D. ANNOTATED MARKED-UP DRAWINGS  
WITH ATTACHMENT REPLACEMENT SHEETS  
AND FORMAL DRAWINGS

**RESPONSE**

This Amendment is responsive to the First Office Action on the merits in this matter, mailed June 2, 2003. In view of the amendments and the remarks made herein, the applicant respectfully requests reconsideration and further examination of this application.

FIG. 7

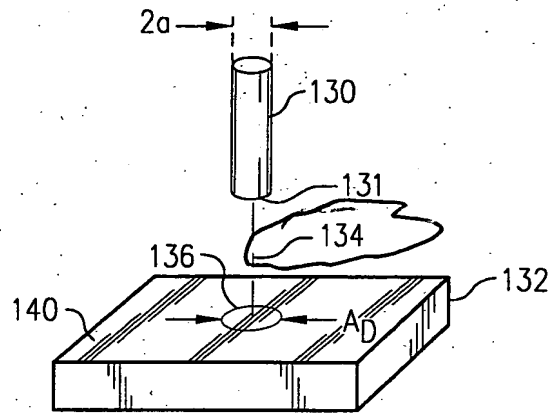
Proposed amendments to FIGS. 7, 21, 26, 31, 61, 68, 76, 131 and 148 are provided to bring the drawing into conformance with the specification.
